# **Receiver performance evaluation**

(comments #324, #325, and #326)

IEEE P802.3dj Task Force

September 2024 (r1)

# Definition of a block

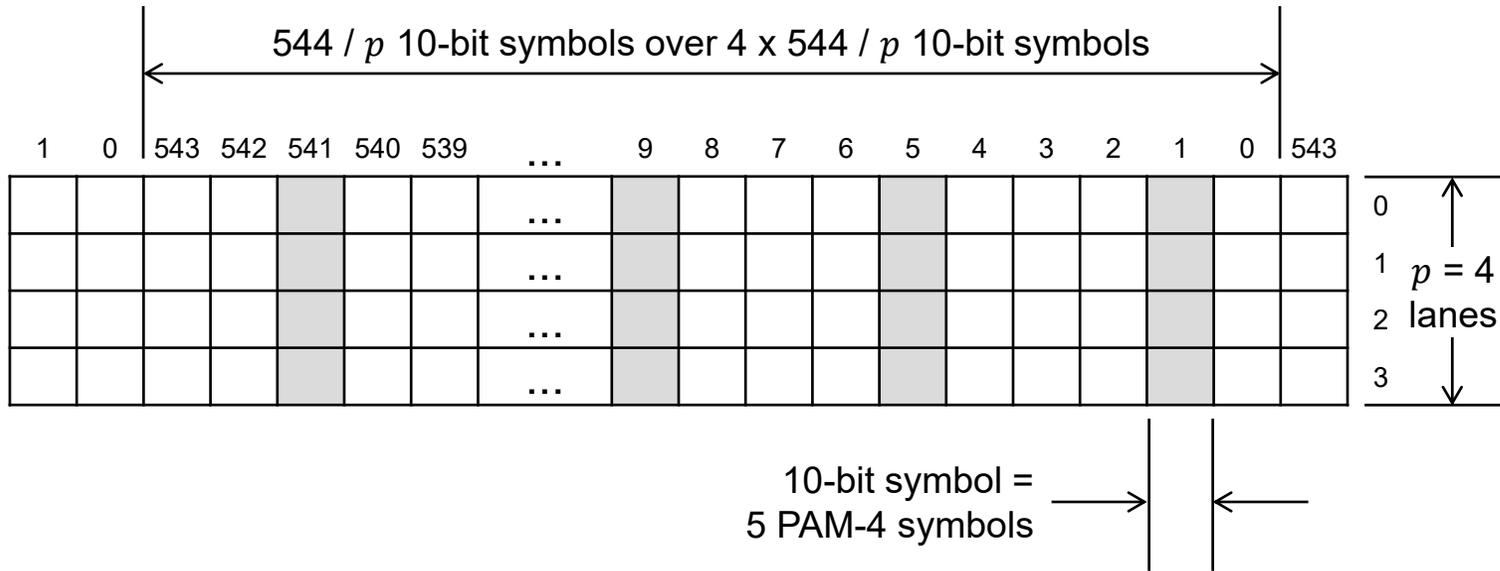
- This is not consistent with the structure of the data on an ISL lane (comment #326)
- 10-bit symbols from 4 different codewords are interleaved on each 200G lane
- 10-bit symbols from a codeword are separated by 3 10-bit symbols from other codewords
- Each codeword spans  $4 \times 544 / p$  symbols on a given lane for an  $p$ -lane ISL
- Therefore, for the block error ratio to reflect the impact of errors on encoded data, a block should consist of every fourth 10-bit symbol
- A block should consist of  $544 / p$  symbols spanning  $4 \times 544 / p$  symbols (with every fourth symbol being considered in the count)
- Multiple blocks may be measured in parallel to reduce measurement time

# Example for 800 Gb/s Ethernet

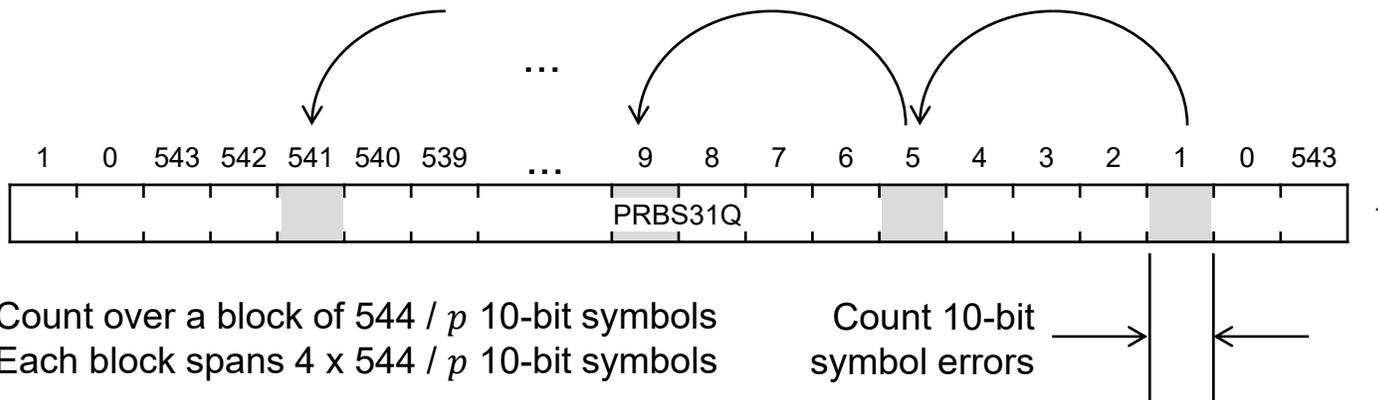
- Structure of the encoded data on the ISL (or at the input / output of the inner FEC when included)
- Shaded squares represent 10-bit symbols within the same codeword

Consider every fourth 10-bit symbol in the error count

- Single lane test using PMA pattern generator and a pattern checker that counts errors in a way that is consistent with how encoded data will be processed
